Product Change Notification

MultiConnect[®] Cell 100 Series QuickCarrier[®] USB-D LTE Cat M1 Cellular Modems and Dongles

PCN 12072020-00

Release Notes

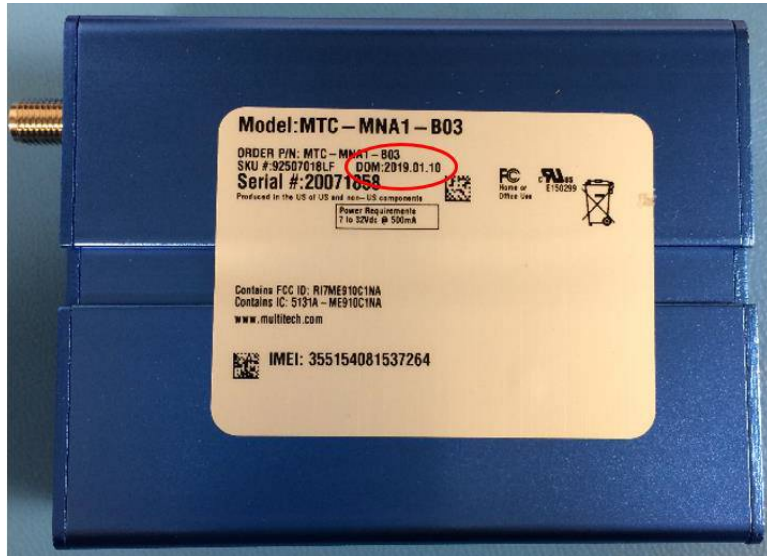
Release of new radio firmware.

Current Radio Firmware Version

30.00.XX3

New Radio Firmware Version

30.00.XX8
